UNITED STATES PATENT AND TRADEMARK OFFICE

10/042,567

Office Action Summary

DETAILED ACTION

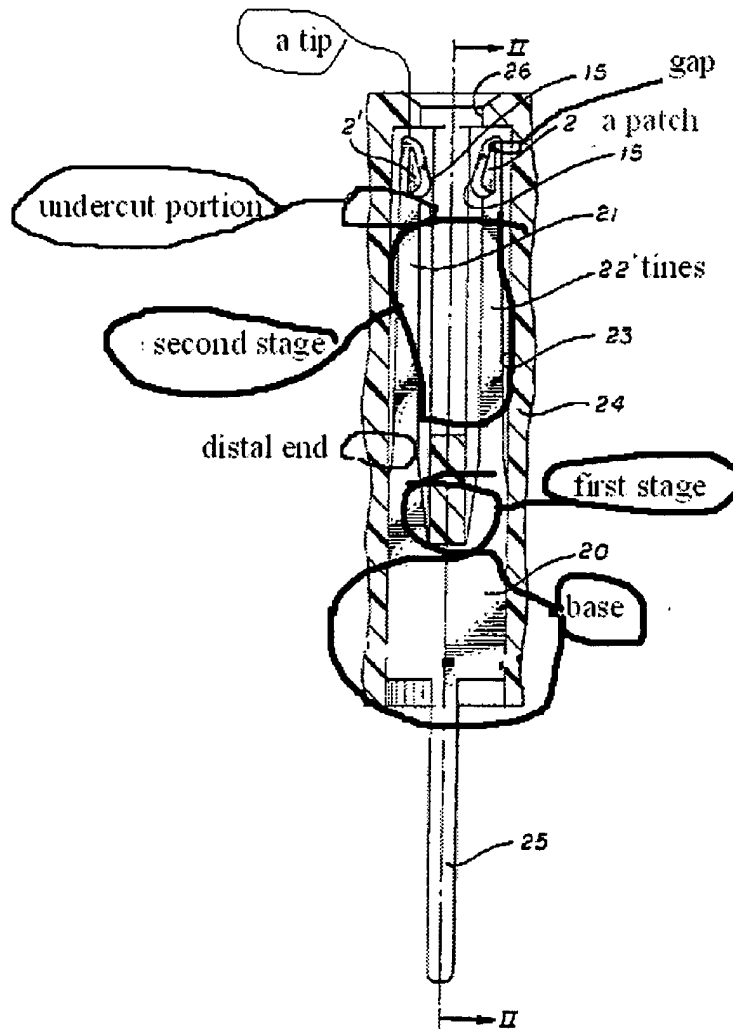
-- In reference to Claim(s) 3, Frommer shows (see examiner's figure)

providing at each of the plurality of tines 22 a first stage proximate a base that includes a first inner diameter and a second stage that is disposed intermediate between a tip and the first stage and where the second stage includes a second inner diameter at the one end thereof that is greater than the first inner diameter and wherein each of the plurality of tines includes a patch proximate ~~a~~ the tip, the patch having a thickness that is greater than an adjoining undercut portion.

-- In reference to Claim(s) 5, Frommer shows (see examiner's figure) each of the tines 22 includes a first stage and a second stage, the first stage having a first wall thickness that is thicker than a second wall thickness of the second stage that is disposed proximate to the first stage and which extends therefrom toward a tip of each tine.

-- In reference to Claim(s) 6, Frommer shows the means for receiving a pin in the socket includes providing an undercut portion (see examiner's figure) in each of the tines a predetermined distance from the tip.

-- In reference to Claim(s) 7, Frommer shows (see examiner's figure) the undercut portion extends to the first stage.

-- In reference to Claim(s) 8, Frommer shows (see examiner's figure) each of the tines includes a patch of material that is adapted to contact a pin, the patch being disposed intermediate the tip and the undercut portion.

-- In reference to Claim(s) 9, Frommer shows (see examiner's figure) the patch of material includes a greater thickness of material than the undercut portion.

-- In reference to Claim(s) 13, Frommer shows (see examiner's figure) a gap.

-- In reference to Claim(s) 14, Frommer shows (see examiner's figure) each of the plurality of tines have curved portions (at the patch shown in the examiner's figure)).

-- In reference to Claim(s) 15, Frommer shows (cover sheet) the socket 20 includes a hood 24 having a predetermined inside diameter that surrounds the plurality of tines, and wherein when a pin is mated inside of the socket, the plurality of tines extend radially outward a greater amount at the tip than at the distal end (see examiner's figure), and wherein a gap (see examiner's figure)
